PROJECT: Cliff Shadows S Hickam - Update #1

| <b>SUBJECT:</b>                                                            | Drainage Study for:                           | <b>COPIES TO:</b>                                                                                                                                                                        |
|                                                                            | <b>Cliff Shadows &amp; Hickam – Update #1</b> | Triton Engineering                                                                                                                                                                       |

**Subject: Addendum #1 to Update #1 to the TDS for Cliff Shadows & Hickam  
DS5270B**

STORM DRAIN  
PLAN AND PROFILE

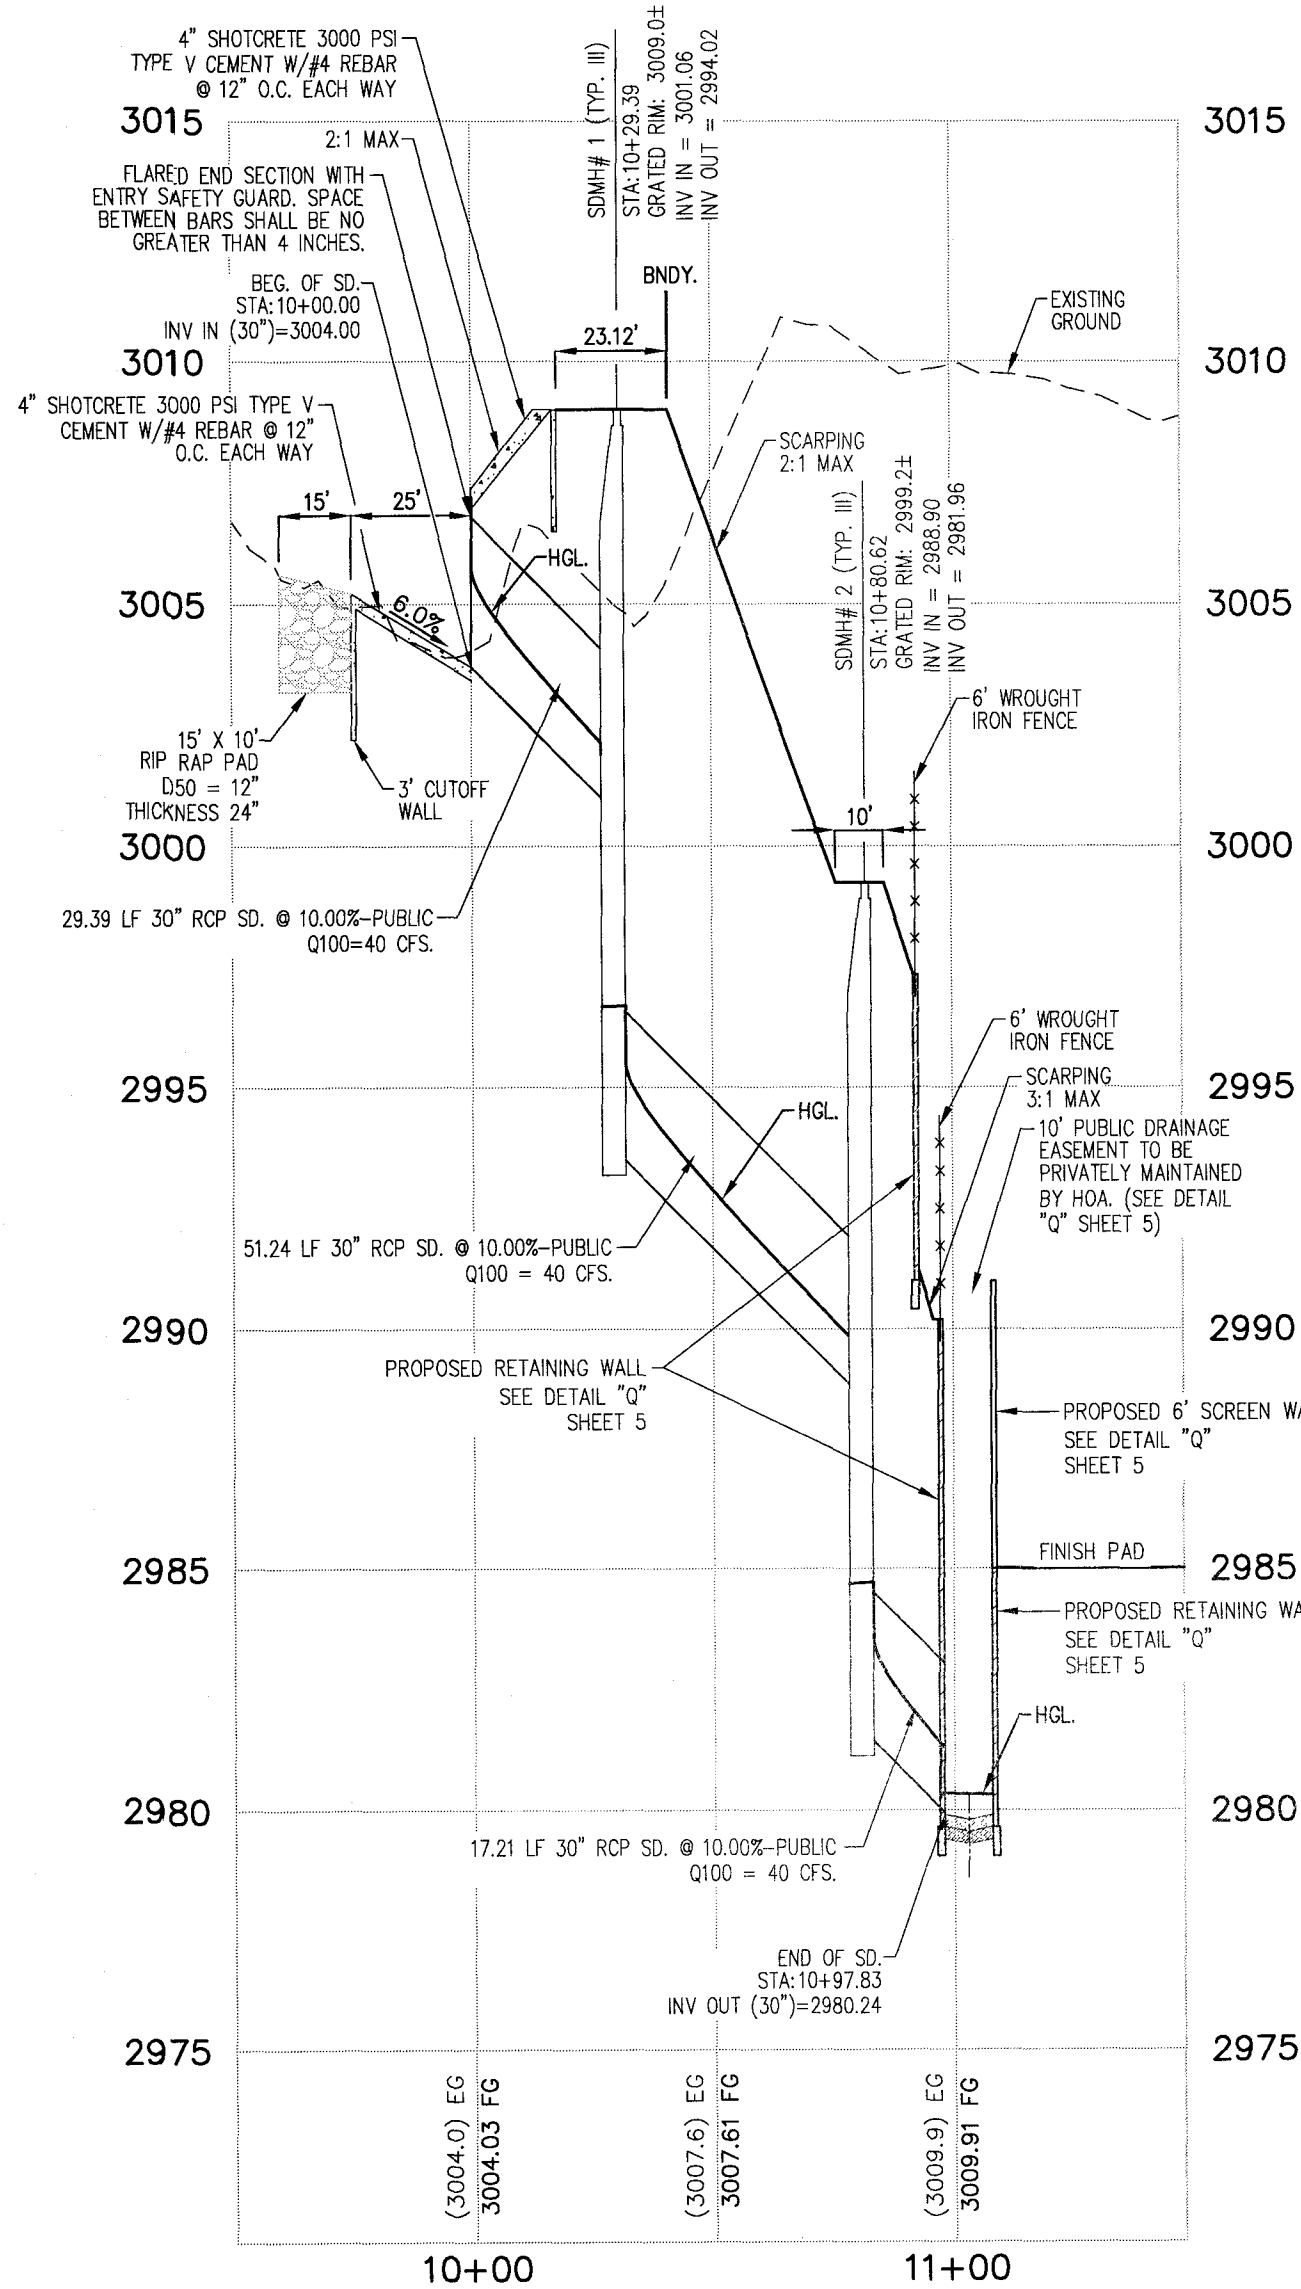
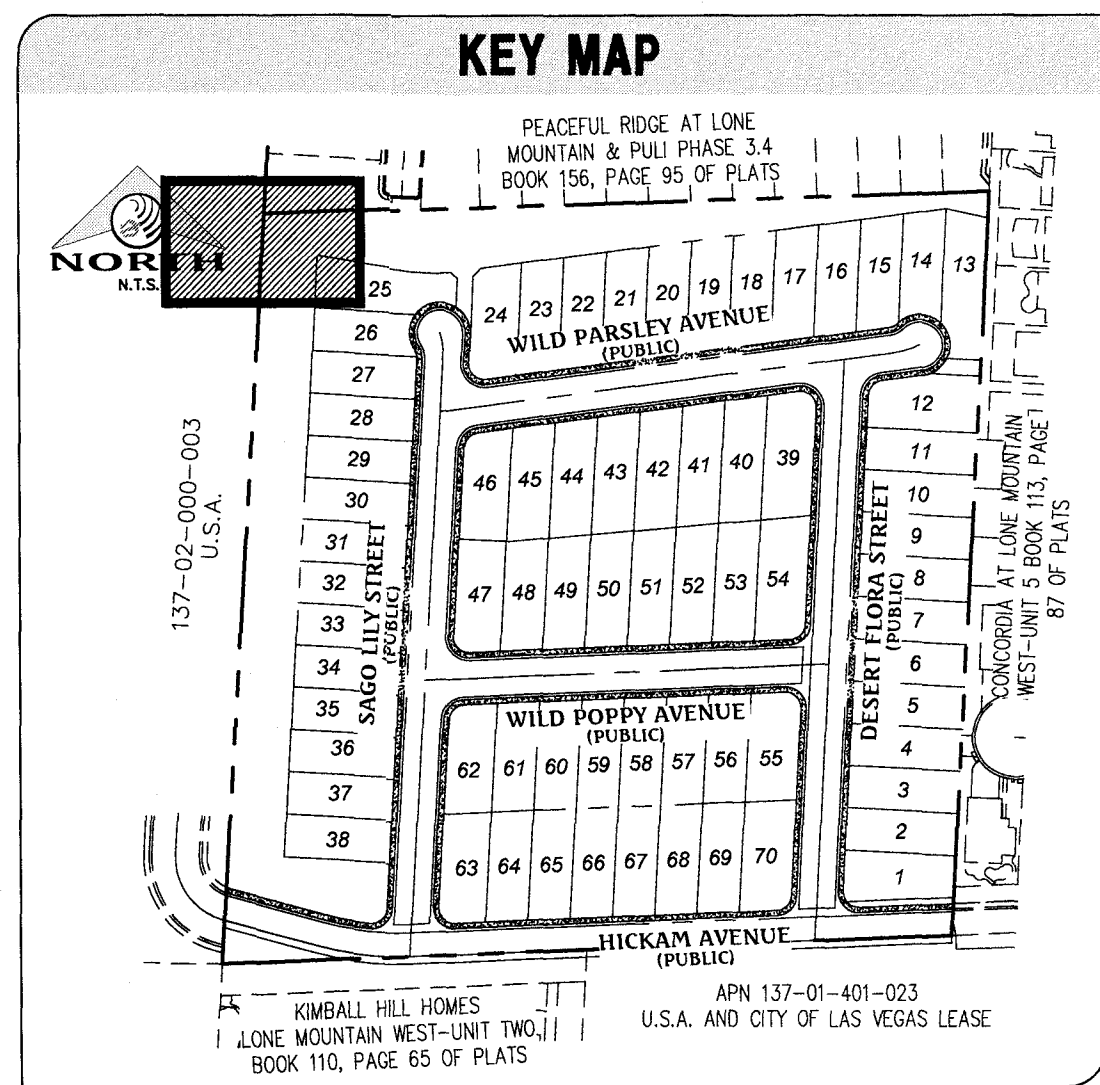
- Although called out on the Grading Plans with a note and a leader, show the proposed storm drain manholes.

2. **Revise the invert elevations in the WSPG models and/or Profiles so that they match.**

This has been corrected. Please see the attached revised WSPG models. Please note that the storm drain size was reduced from a 36" RCP to a 30" RCP which had negligible impacts to the results. A revised nomograph calculation is also attached to estimate the minimum headwater depth necessary to intercept the 40 cfs at the inlet.
